BURNT HILL BRIDGE OVER LITTLE BENNETT CREEK MANDATORY REFERRAL (MR2025014)

No. MR2025014

05/01/2025

Figure 2: Plan View of Proposed Bridge Design

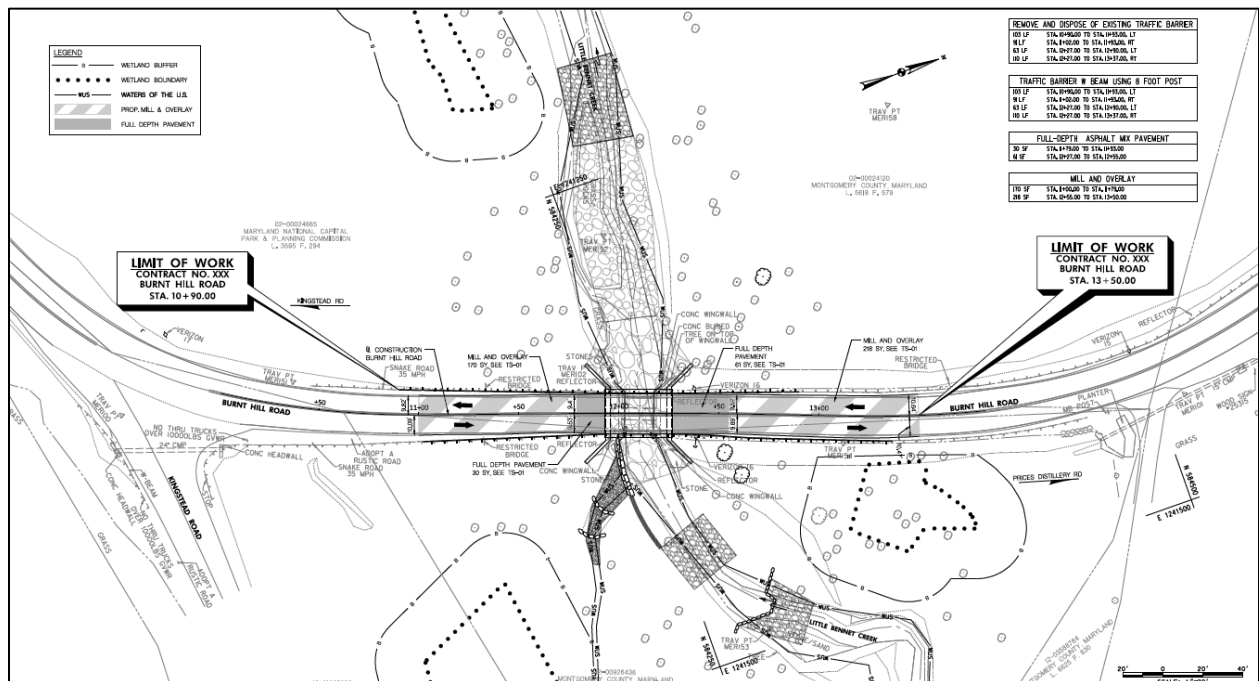
The new design is of a larger scale than the existing bridge, but MCDOT appears to have made every effort to minimize the new bridge's size. The design of the bridge is similar to the existing bridge, which helps preserve the rustic character of the road.

Figure 10: Extent of Stream Work

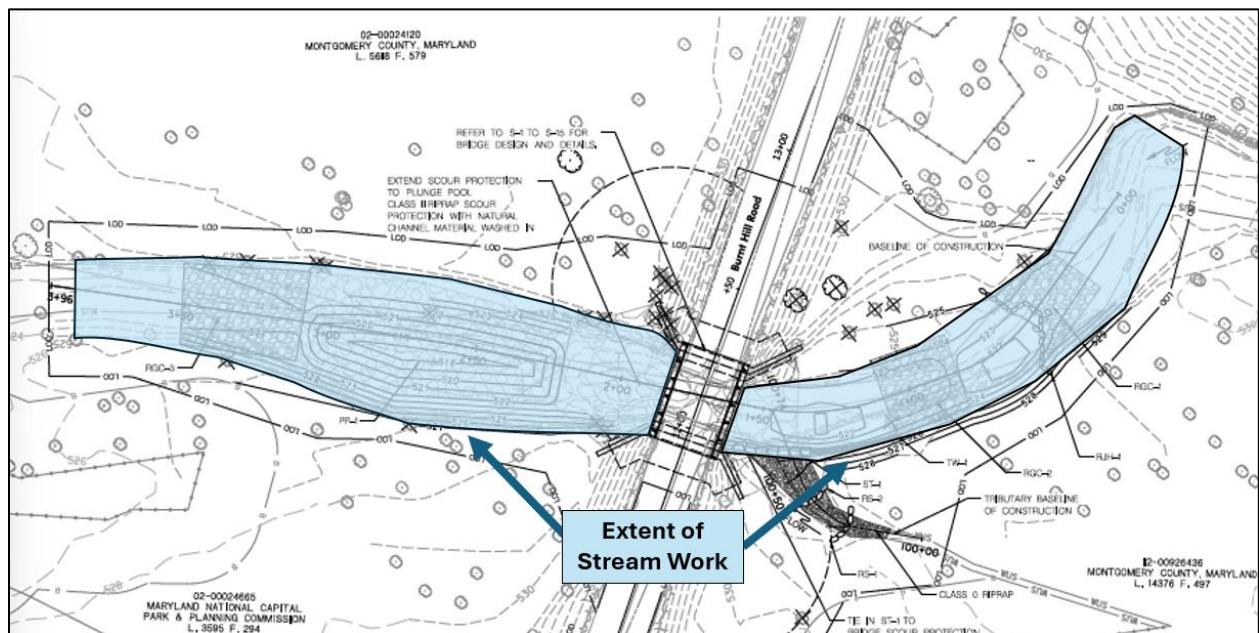
MCDOT will include Natural Channel Design instream stabilization and enhancement features (per Parks Standard Details) upstream (~200 feet) and downstream (~225 feet) of the new bridge. Traditional bridge construction techniques generally reduce the stream width and harden the banks, which accelerates stream flows and increases the erosive force of the water. However, this proposed bridge will be approximately 10' 9" longer than the existing bridge and will accommodate larger stormflows, less erosive flows, and improved aquatic passage. Montgomery Parks appreciates MCDOT's commitment to improving the stream condition at Little Bennett Creek by building a new bridge with more capacity for the stream and restoring eroded banks upstream and downstream of the bridge. In addition, stream habitat will be improved by the construction of stable riffles and pools that provide varied aquatic habitat. Finally, the drainage channel from the existing wetland upstream of the bridge will be stabilized with rock sills and rip-rap material, and will tie into the existing stream channel.

3. **MCDOT will continue to coordinate with M-NCPPC on the design of the required instream structures in Little Bennett Creek to ensure that a stable stream setting is provided.**

Figure 11: Area of Proposed Right-of-Way, highlighted in yellow.

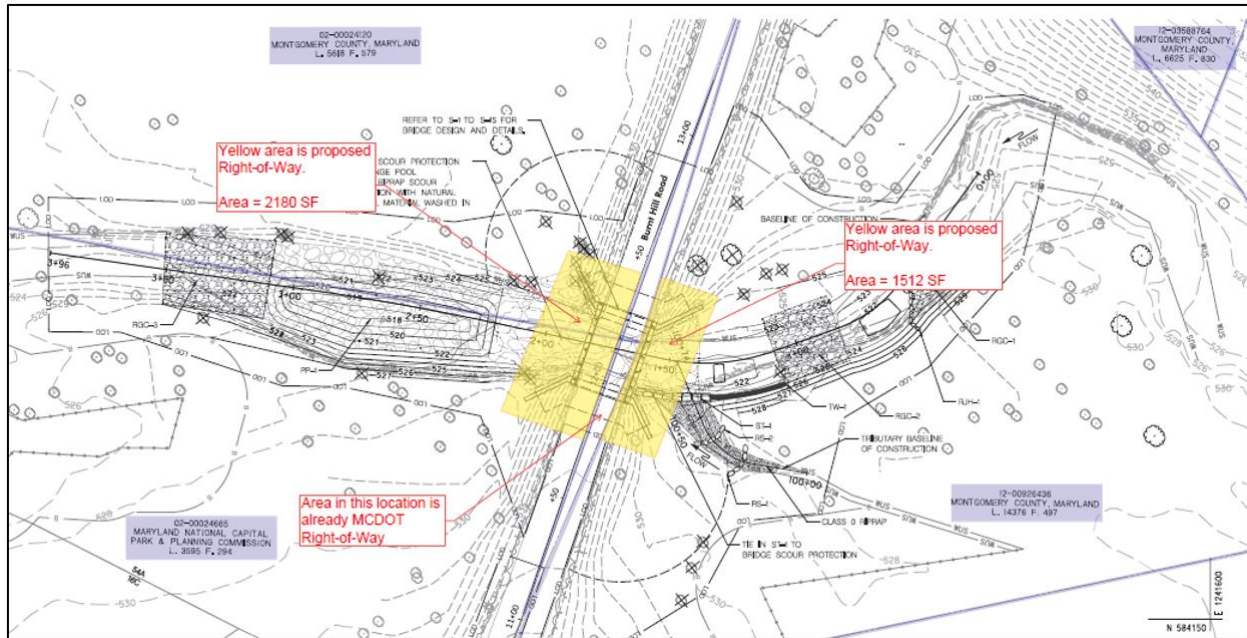
The current project design requires approximately 2,180 square feet (0.05 acre) of Little Bennett Regional Park and approximately 1,512 square feet (0.035 acre) of Little Bennett Creek Stream Valley Park to be added to the MCDOT ROW to accommodate the new bridge structure, creating a permanent impact to the park.

Since the funds used to acquire this land were appropriated to the Commission for parks and open space purposes, M-NCPPC Montgomery Parks must be compensated at fair market value for the land area that will no longer be serving park purposes. Payment for the new ROW area must be made to Montgomery Parks prior to issuance of the Park Construction Permit. Commission land that is proposed to be transferred to MCDOT is highlighted in Figure 5 below.

2. **MCDOT must compensate the M-NCPPC at fair market value for all land that will transfer from M-NCPPC to MCDOT's road right-of-way (ROW), estimated at approximately 3,692 sf. Payment for the transferred land must occur before issuance of the Park Construction Permit. The new ROW will be transferred to MCDOT by M-NCPPC via a Release Agreement and via perpetual easement, recorded in the County Land Records.**
